## DSP-99044-07

Application	General Data	
<b>Project Name:</b> Prince George's Plaza, Parcel A-1 Chick-fil-A  <b>Location:</b> Located at the northeastern quadrant of the intersection of East-West Highway (MD 410) and Belcrest Road.  <b>Applicant/Address:</b> Chick-fil-A 5200 Buffington Road Atlanta, GA 30349	Planning Board Hearing Date:	10/31/13
	Staff Report Date:	10/16/13
	Date Accepted:	08/29/12
	Planning Board Action Limit:	Waived
	Plan Acreage:	51.03
	Zone:	C-S-C/T-D-O
	Dwelling Units:	N/A
	Gross Floor Area:	5,030 sq. ft.
	Planning Area:	68
	Tier:	Developed
	Council District:	02
	Election District:	17
	Municipality:	Hyattsville
200-Scale Base Map:	208NE03

SUBJECT: Detailed Site Plan DSP-99044-07  
Prince George's Plaza, Chick-fil-A

# RENDERED LANDSCAPE PLAN

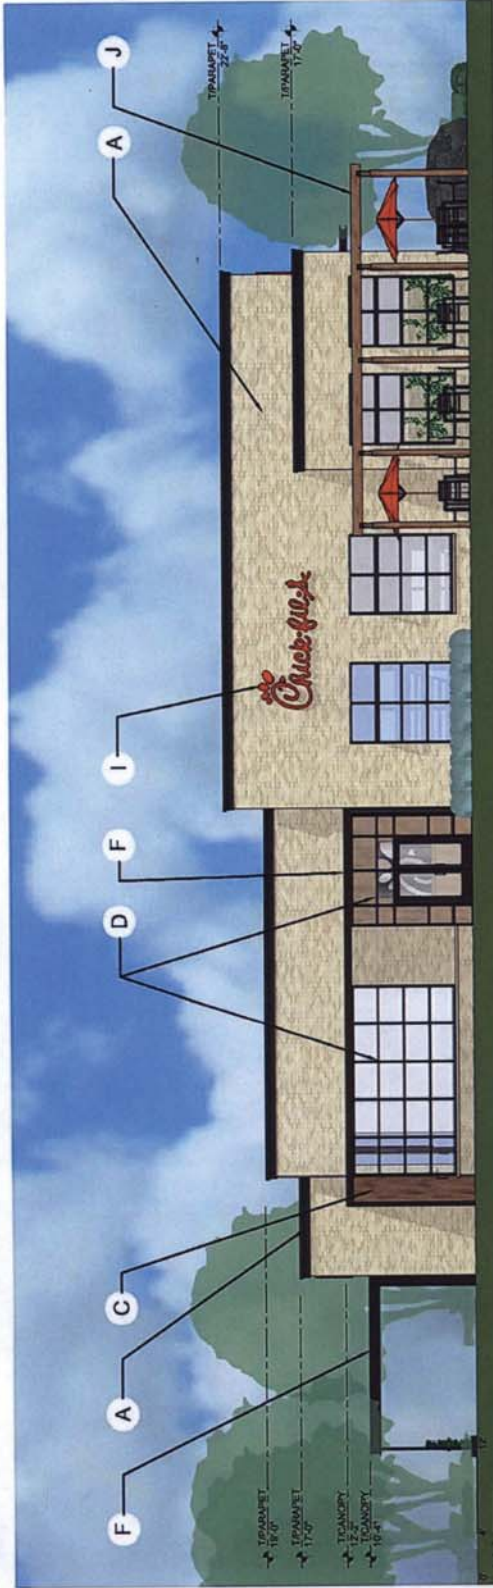
- e. **Section 4.9, Sustainable Landscaping Requirements**—This DSP application is subject to Section 4.9, which requires that a percentage of the proposed plant materials be native plants. The plant schedule does not designate which plants are native species. This information should be provided on the DSP prior to certification.

- l. Revise the plant schedule to designate which plants are native species.
  - m. Provide a plan note that indicates the applicant's intent to conform to construction activity dust control requirements as specified in the 2011 Maryland Standards and Specifications for Soil Erosion and Sediment Control.

1 STREET ELEVATION  
3/16" = 1'-0"

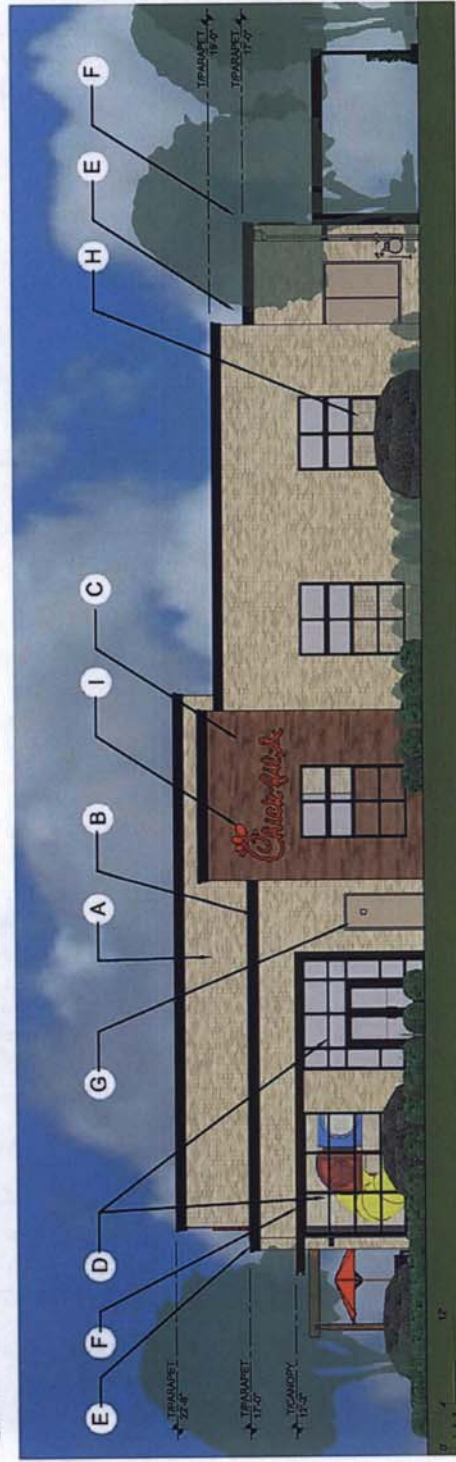
The windows propose multiple panes of glass. Metal green screen frames are proposed to be mounted below the windows along the East-West Highway and parking lot elevations to allow for climbing plants. Along the East-West Highway elevation, some improvements to the fenestration appear warranted. The three equally-sized windows proposed along this elevation appear small

and inconsequential with too much space in between. Modifications of the fenestration, including larger windows with less space in between each, would give this elevation the additional visual prominence that is warranted along East-West Highway.

**Comment:** Staff believes that the sense of arrival on the southern façade, facing East-West Highway, would be improved with a more balanced fenestration and an enhanced window treatment to give this elevation the prominence that is warranted due to its highly visible location.

- (1) Revise the south building elevation facing East-West Highway to improve the appearance by enlarging the windows and reducing the space in between each window.

2 DRIVE-THROUGH ELEVATION  
3/16" = 1'-0"

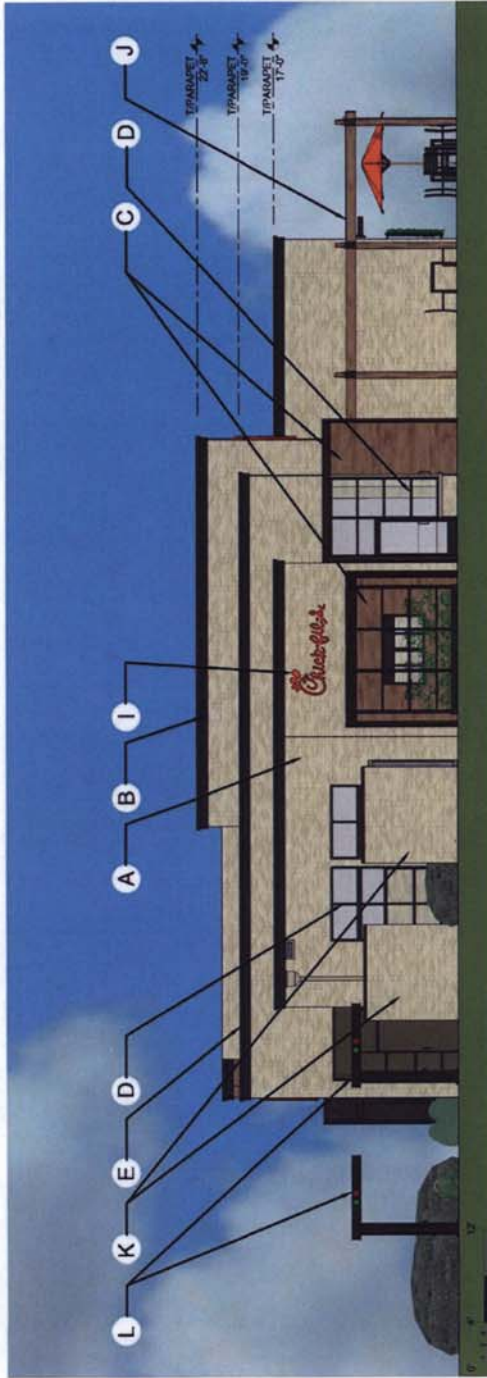
**Drive-Through Service Window**—The planned configuration of the drive-through service queuing and departure areas ensures direct pedestrian access to the proposed restaurant from the streetscape and eliminates a previously proposed drive-through form that would have wrapped the building with paved loading and queuing areas. This new configuration represents a significantly improved approach over the initial layout of the proposed development. However, the drive-through component by its very nature is contrary to the goals for the Prince George's Plaza Transit District. It is not a transit oriented form of development and is designed to accommodate the automobile. The proposed drive-through and double queuing lanes are located directly adjacent to the pedestrian zone along East-West Highway. While a low wall would exist between the drive through and the pedestrian zone, vehicle exhaust and lighting associated with drive-through and queuing lane would provide negative impacts to the pedestrian realm. Queuing lanes for the drive-through begin 12 feet from the existing sidewalk. For this reason and the overall goals of the TDDP, staff recommends the removal of the drive-through feature.

1. Prior to signature approval of the plans, the applicant shall revise the detailed site plan or provide additional information as follows:
  - a. Revise the plan to remove the drive-through service window, vehicular lanes and all other plan elements associated with the feature and convert the area into parking, green space, and/or amenity space.
